**ISO/IEC JTC 1/SC 6**

<b>Document Number:</b>	N14199
<b>Date:</b>	2010-01-28
<b>Replaces:</b>	
<b>Document Type:</b>	Disposition of Comments
<b>Document Title:</b>	Disposition of Comments on the ISO/IEC DIS 13157
<b>Document Source:</b>	Barcelona BRM
<b>Project Number:</b>	
<b>Document Status:</b>	For your information.
<b>Action ID:</b>	FYI
<b>Due Date:</b>	
<b>No. of Pages:</b>	23
<p>ISO/IEC JTC1/SC6 Secretariat Ms. Jooran Lee, KSA (on behalf of KATS)</p> <p>Korea Technology Center #701-7 Yeoksam-dong, Gangnam-gu, Seoul, 135-513, Republic of Korea ;</p> <p>Telephone: +82 2 6009 4808 ; Facsimile: +82 2 6009 4819 ; Email : <a href="mailto:jooran@kisi.or.kr">jooran@kisi.or.kr</a></p>

<b>Template for comments and secretariat observations</b>	Date: 2009-11-12	Document: <b>DoC ISO/IEC DIS 13157</b>
---	------------------	--

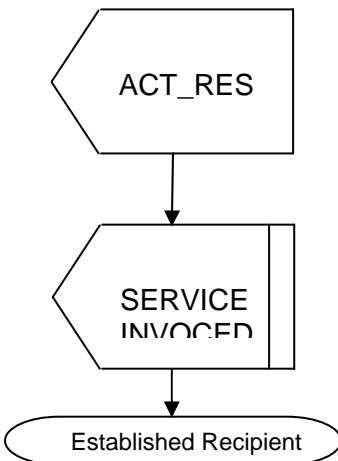
FR33	Annex A.3	List of SDUs	Te	<p>When the Recipient receives the PDU ACT_REQ and answers with a PDU ACT_RES , an SDU should be sent to the NFC-SEC USER to report that a NFC-SEC Service has been requested. This information informs the USER layer that the NFC-SEC entity has moved to the “Established Recipient” State and is no longer able to receive the SDU of the Idle State ( refer to FR comment</p> <p>This SDU should include the type of the service and the Security Context Identifier</p>	<p>Add the following Confirm SDU to the list</p> <p>“Service Invoked</p> <p>Indicates the receipt of a Service Request ( type of service, SCID)”</p>	<p>Rejected</p> <p>Because NFC-SEC was designed to keep the list of SDUs to a minimum and there is another way to indicate this information: The NFC-USER is informed by the ESTABLISHED SDU.</p>
FR34	Annex A.4	A.4.1	Te	<p>In the IDLE state no PDU conveying a ERROR is expected to be received. The IDLE state is either the initial state or the state acquired after a PDU ERROR is sent or received</p>	<p>Delete</p> 	<p>Rejected.</p> <p>Due to asynchrony in timing, an ERROR PDU may be received immediately after transit to the IDLE state. See also 12.1.</p>
